**REPORT BY THE CHAIRPERSON OF THE
HAGLEY/FERRYMEAD COMMUNITY BOARD**

PART A – MATTERS REQUIRING A COUNCIL DECISION**1. COASTAL PATHWAY – CONCEPT PLAN ADOPTION**

Attachment 1: Amendments to the draft Coastal Pathway Concept Plan

Figures 3.22 - Redcliffs: Moncks Bay - Main Road street sections.

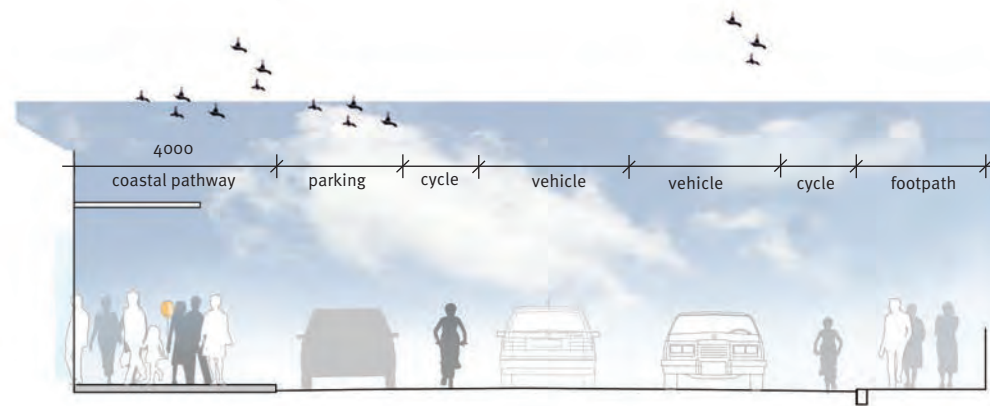
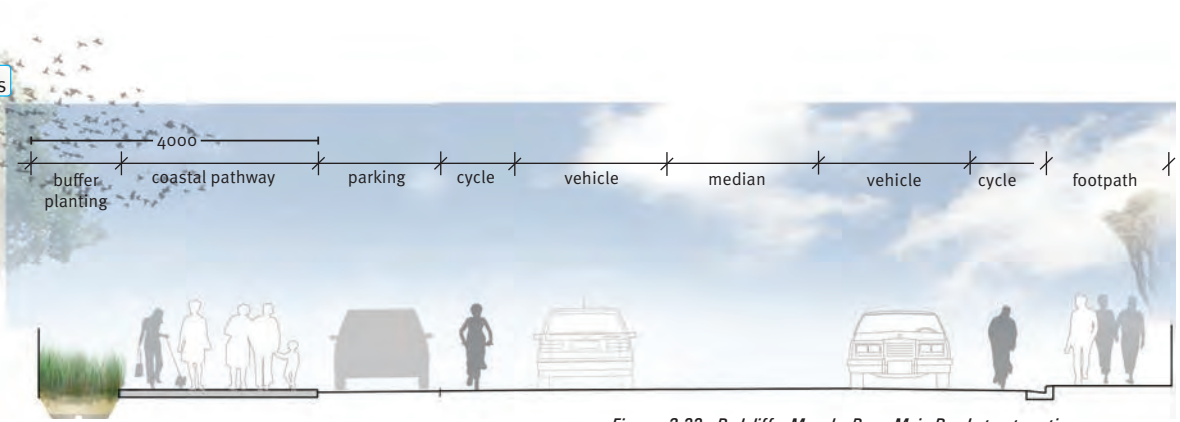
Within the centre of Redcliffs village, the Main Road Master Plan indicated that on-street parking would be lost due to the streetscape works and widening of the pavement to accommodate the Coastal Pathway. This gave rise to a number of submissions expressing concern about the potential adverse effects on the viability of commercial premises and, to a lesser extent, access to residential properties. A revised layout has been developed in conjunction with SCIRT. This enables the retention of on-street parking on the northern side of Main Road while still achieving an extended pavement to accommodate the pathway.

Amend Section 3.3 Concept Design – 04. Redcliffs: Moncks Bay
Revise cross section diagrams R4, R5 & R6 through Redcliffs village centre indicating on-street parking to be retained consistent with the proposed changes to the Main Road Master Plan.
